## ORIGINATION FORM

### Proposed Revisions to a Standard Plans Index

Index Number: 102-607

Index Title:  
Mobile Operations

Sheet Number (s): 1 of 2

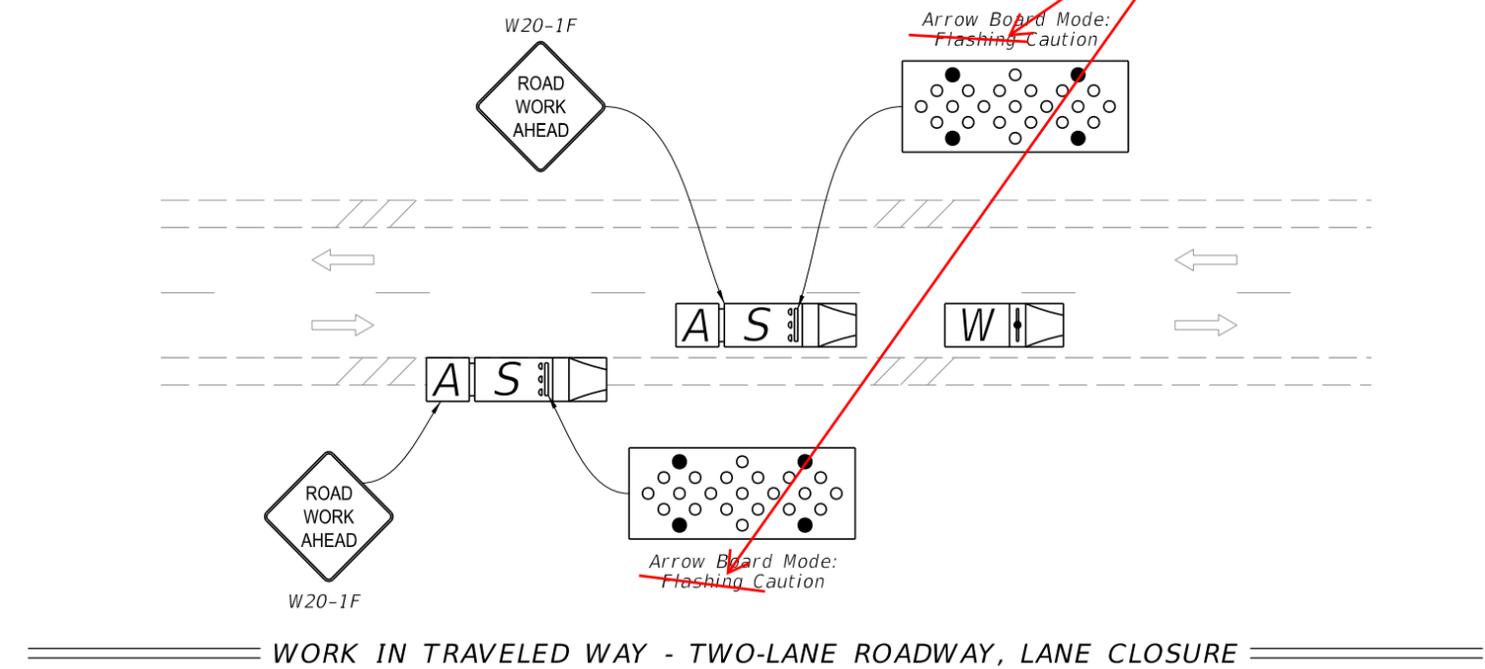
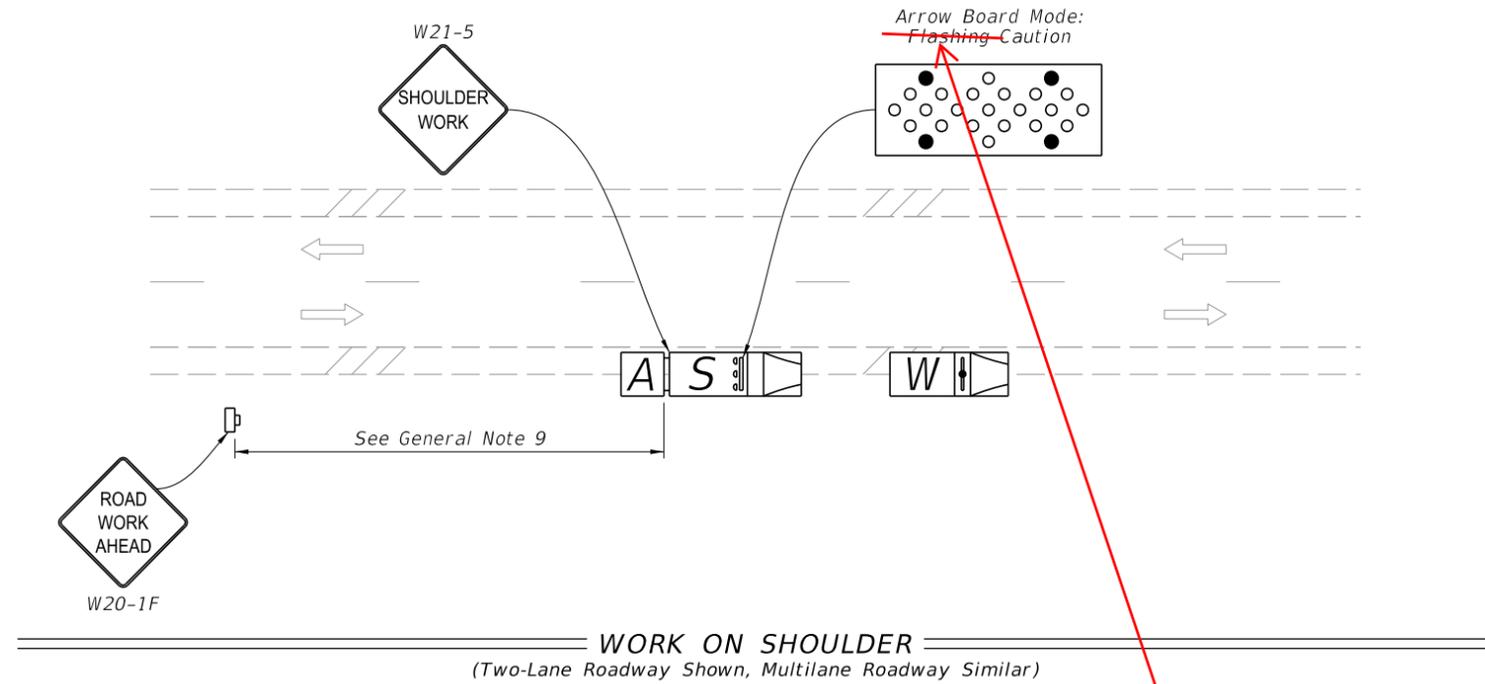
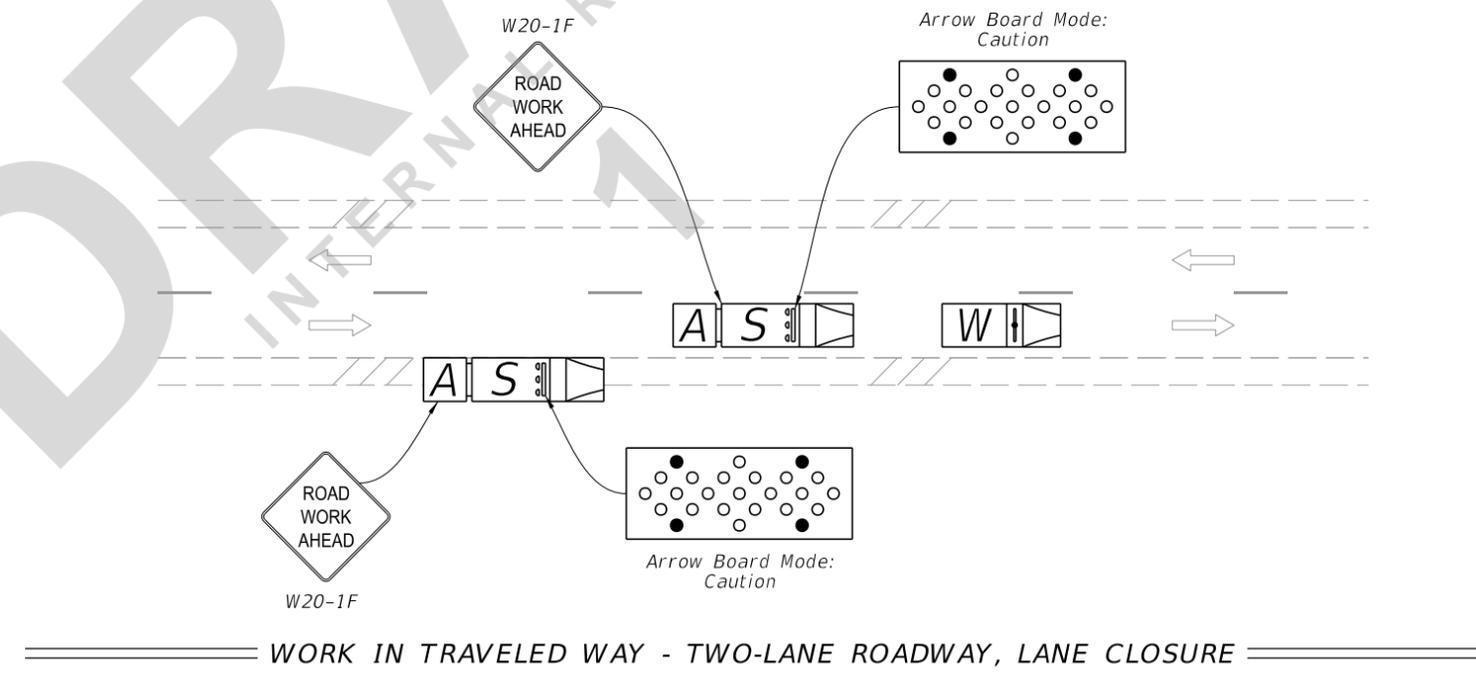
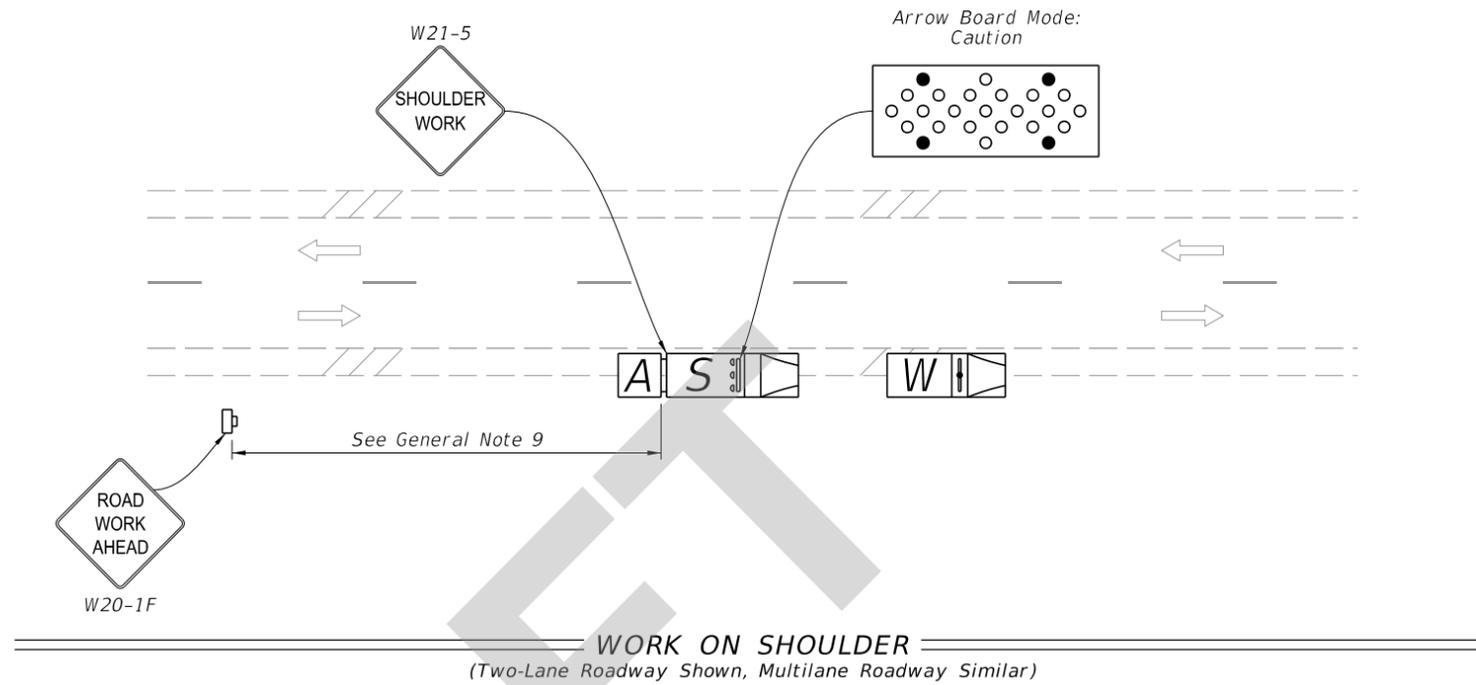
Sheet 1: Deleted "Flashing" from the Arrow Board Mode

**DELETED: Flashing**
